PROJECT / DRAWING TITLE
Hornsey Town Hall

DRAWING TITLE
RESIDENTIAL BLOCK B
South Elevation

HTH: Block B- ,W01D - W05A.2 - solution to be verified

Summer Overheating Assessment

Mark up of window opening changes received 03.12.20

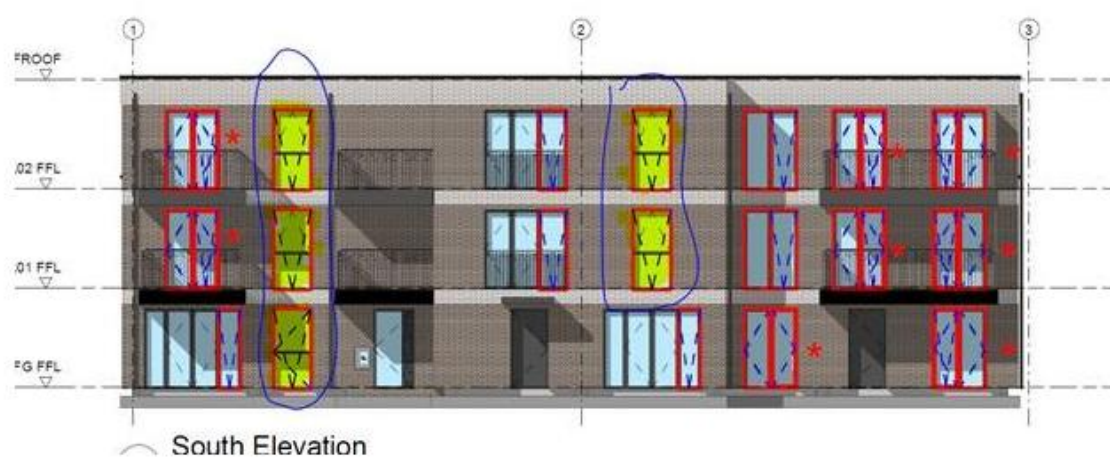
- G value 0.42
- G value 0.4329 to selected doors
- Windows & Doors openable 20 degrees
- Internal doors open 24hrs
- Amended windows as per markup 07.12.20
- NTC to all bedrooms 1st and 2nd floors
- NTC to living rooms tilted windows 1st & 2nd floors
- NTC to rooms with tilted windows and half height bedroom window only on ground floor
- Blinds
- Comfort colling where required

Drawings showing location of windows with g value of 0.4329 received 17.12.20

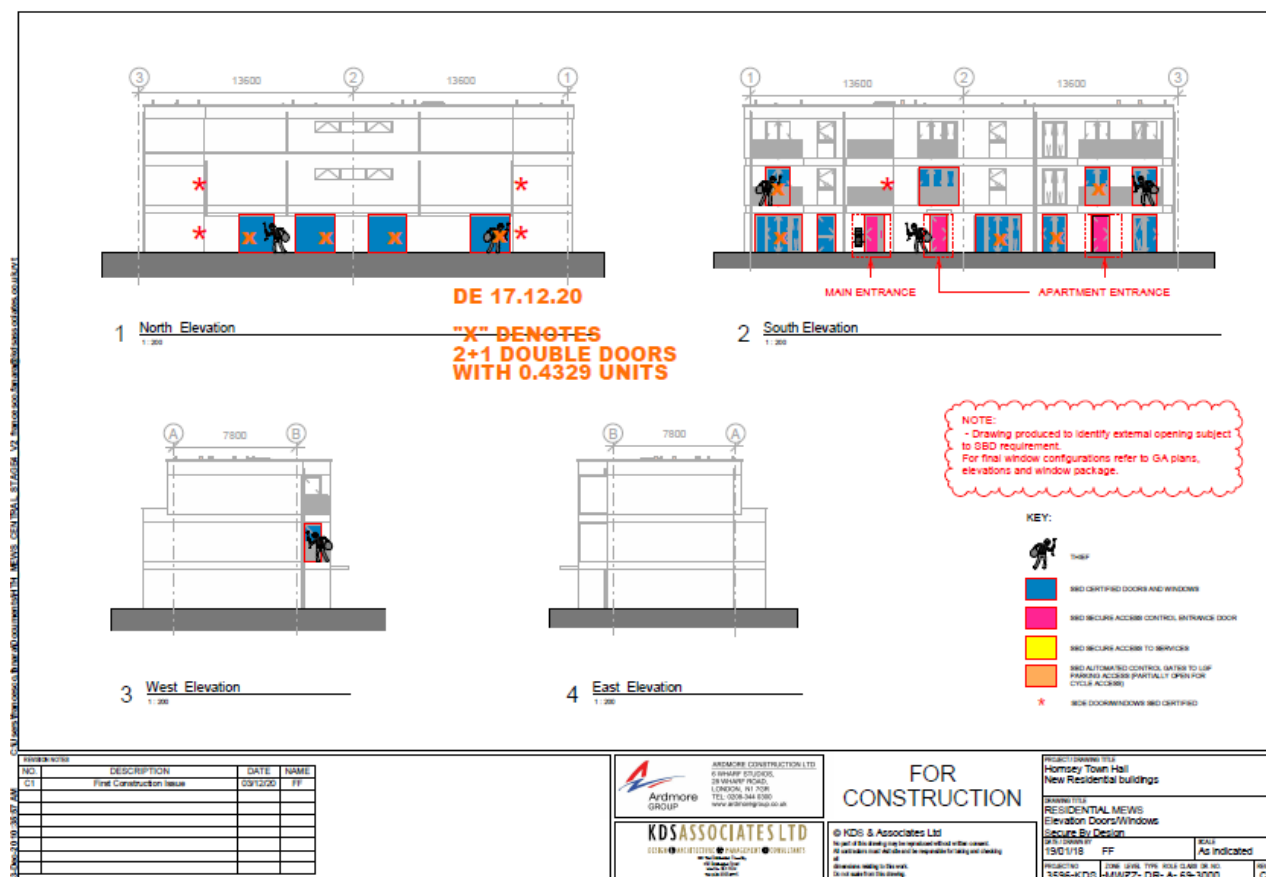
The preferred glazing g-value for the proposed scheme is 0.42 and 0.4329 to lower ground, ground and 1st floor external doors. This reduces solar gains but also still provides sufficient natural daylight, where a lower g-value can often be too dark causing discomfort and an increase in the demand for space heating and artificial lighting.
